DRG SUBMITTAL
G0.1
 Plotted On: 5/26/22

COVER SHEET

CABIN 2 & 4 EXISTING-DEMO & PROPOSED FIRST FLOOR PLAN

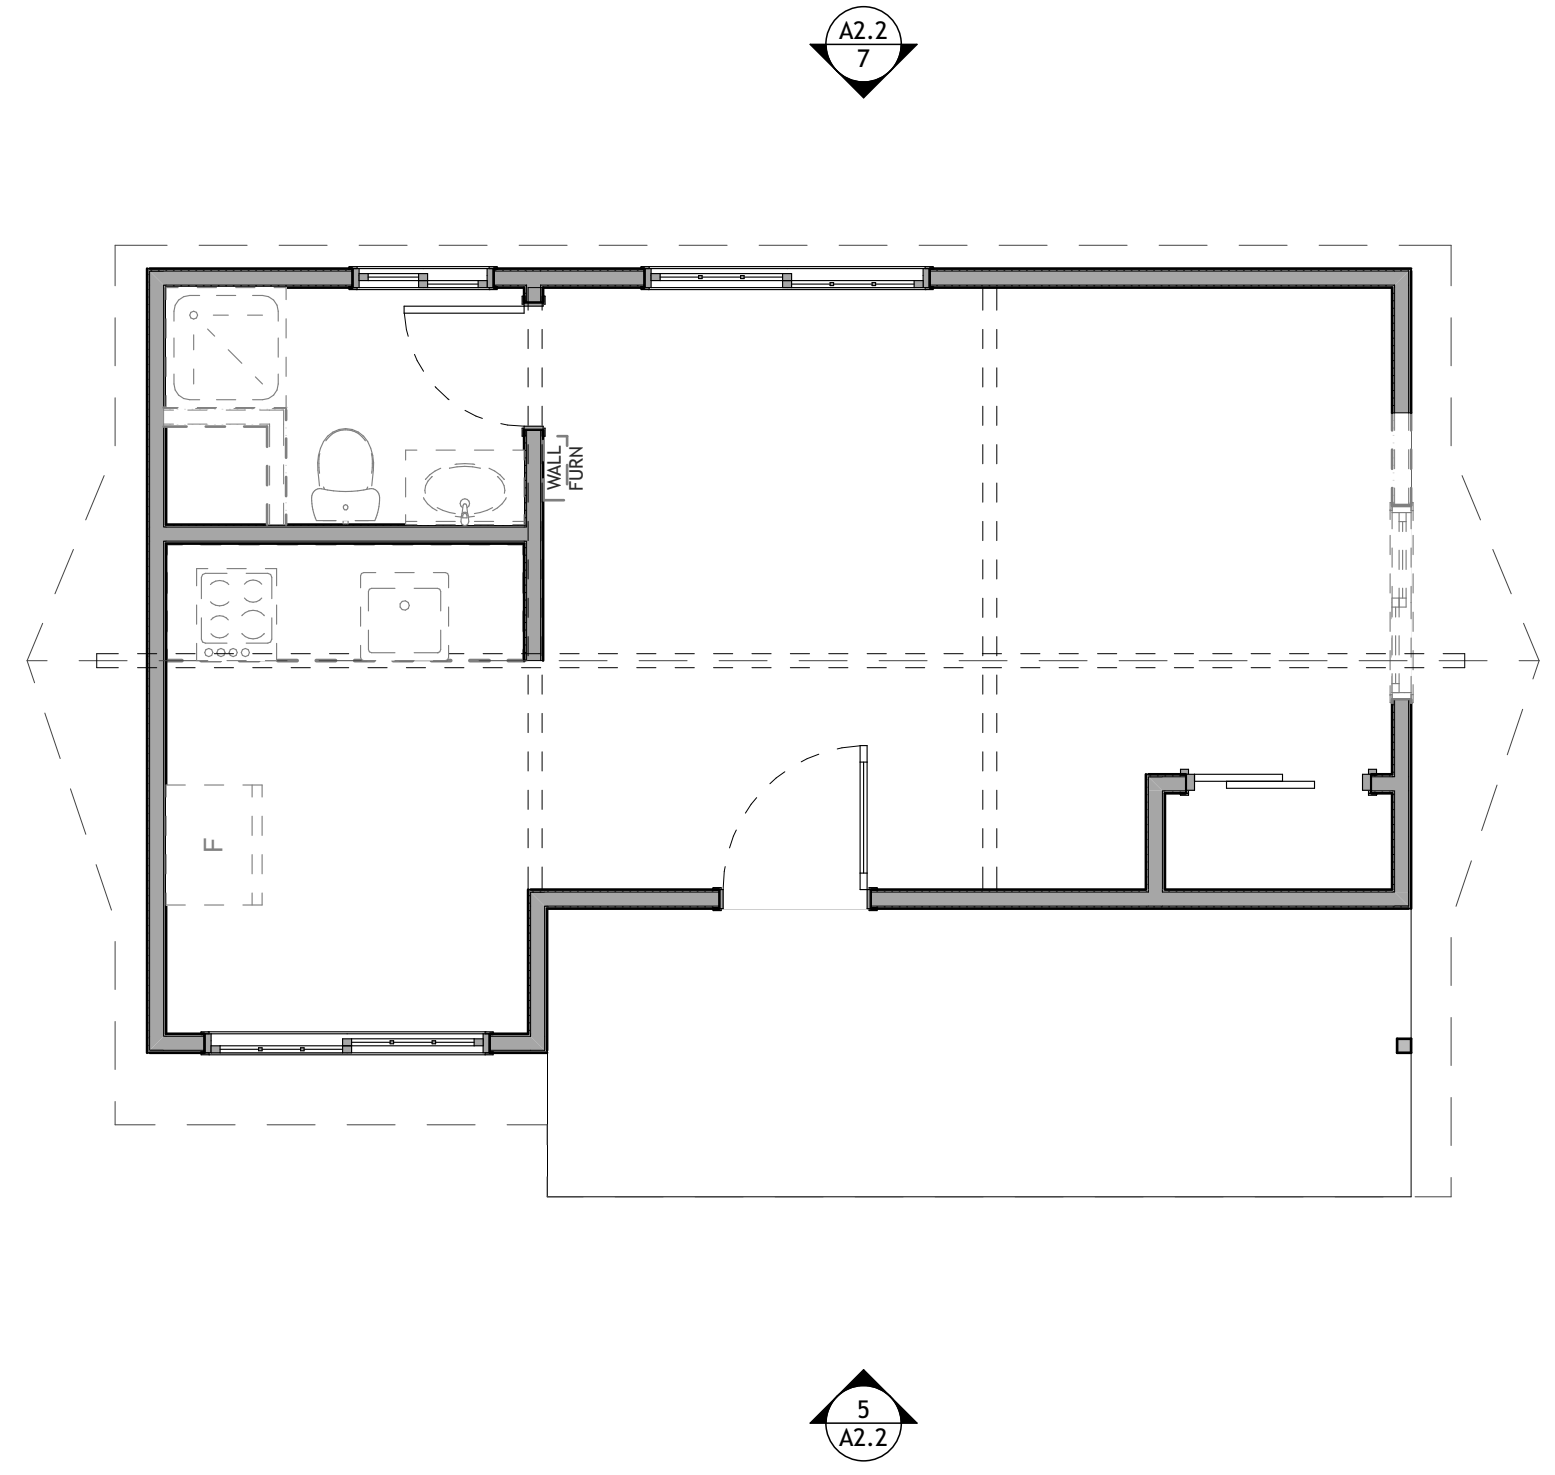
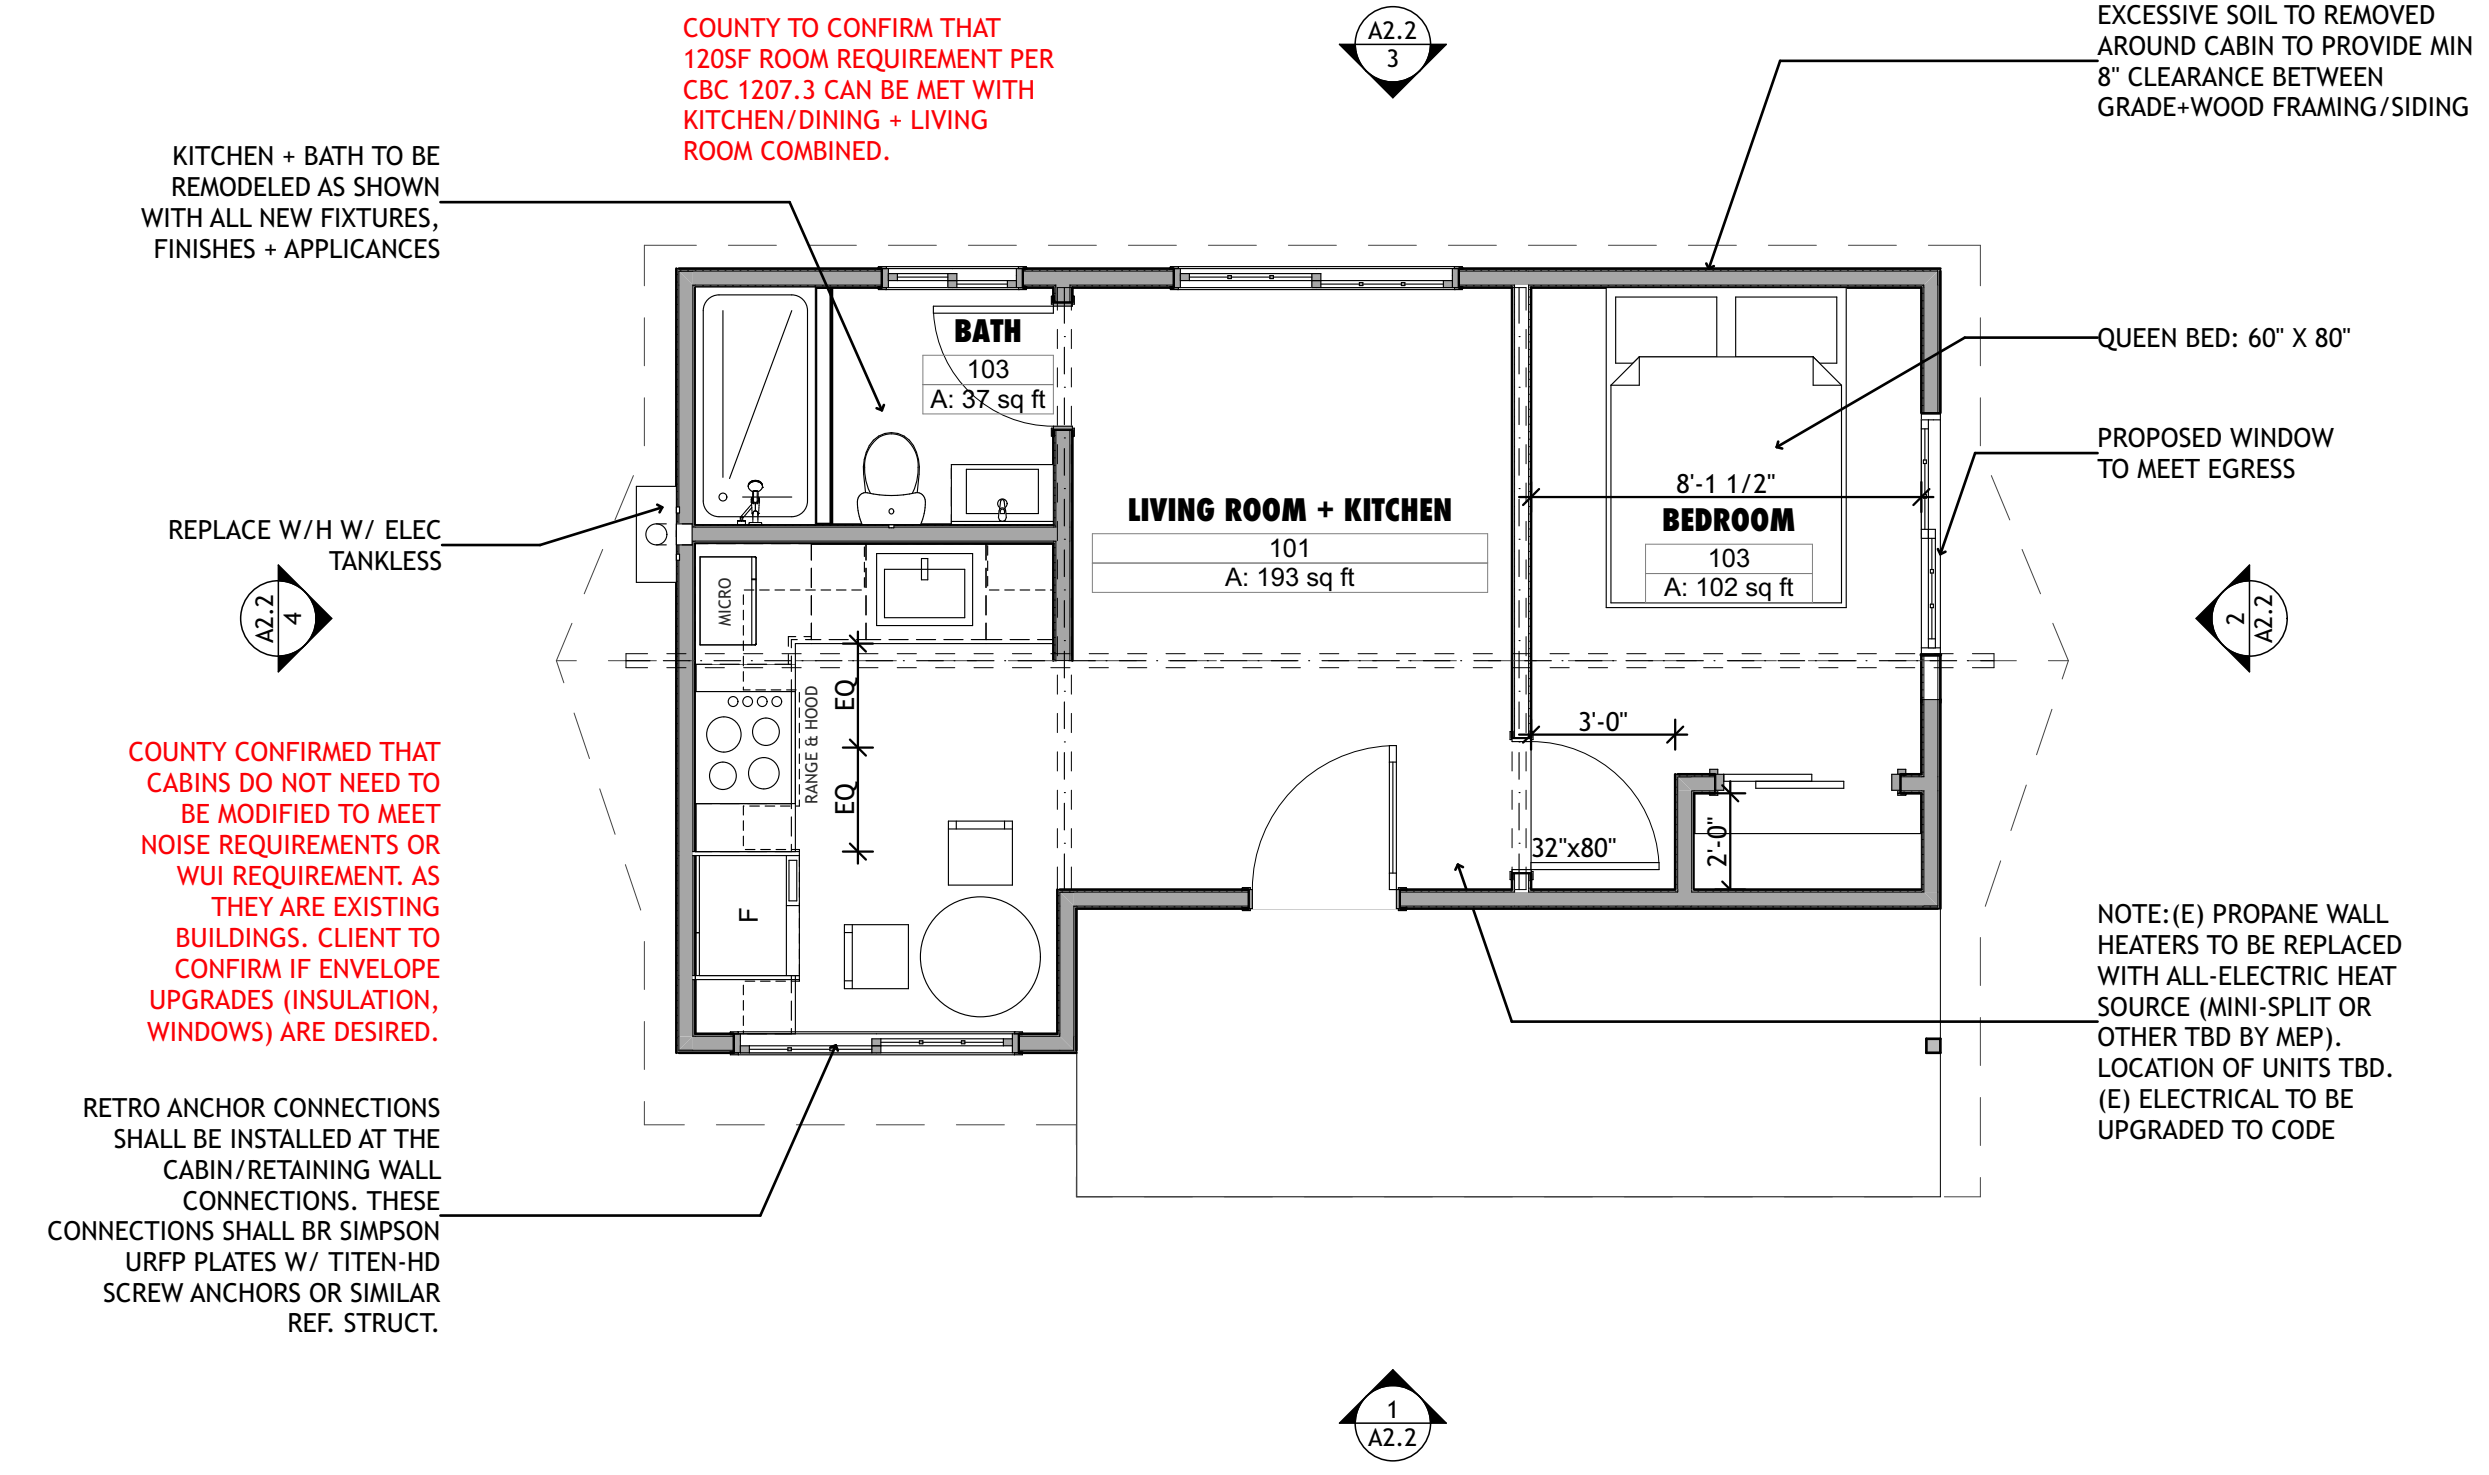
REPLACE W/H W/ ELEC. TANKLESS

COUNTY TO CONFIRM THAT CABINS DO NOT NEED TO BE MODIFIED TO MEET NOISE REQUIREMENTS OR WUI REQUIREMENT, AS THEY ARE EXISTING BUILDINGS. CLIENT TO CONFIRM IF ENVELOPE UPGRADES (INSULATION, WINDOWS) ARE DESIRED.

RETRO ANCHOR CONNECTIONS SHALL BE INSTALLED AT THE CABIN/RETAINING WALL CONNECTIONS. THESE CONNECTIONS SHALL BR SIMPSON URFP PLATES W/ TITEN-HD SCREW ANCHORS OR SIMILAR REF. STRUCT.

COUNTY TO CONFIRM THAT 120SF ROOM REQUIREMENT PER CBC 1207.3 CAN BE MET WITH KITCHEN/DINING + LIVING ROOM COMBINED.

EXCESSIVE SOIL TO BE REMOVED AROUND CABIN TO PROVIDE MIN 8" CLEARANCE BETWEEN GRADE+WOOD FRAMING/SIDING
